STAFF REPORT: 02/11/2026 MEETING

ADDRESS: 1676 CHICAGO

APPLICATION NO: HDC2026-00021

SCOPE: REHABILITATE EXTERIOR (WORK COMPLETED WITHOUT APPROVAL)

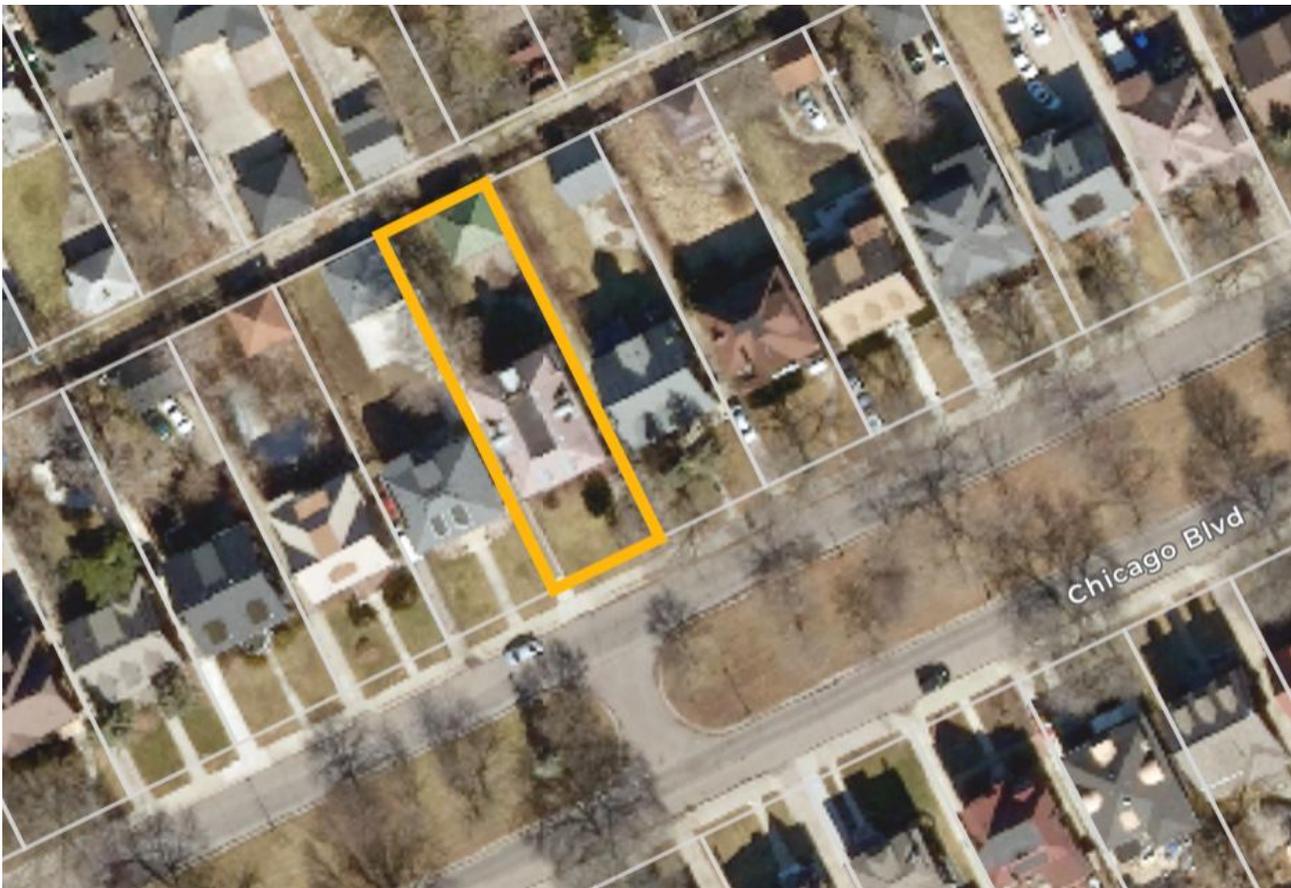
1676 Chicago, garage. Photo by applicant. Facing northeast
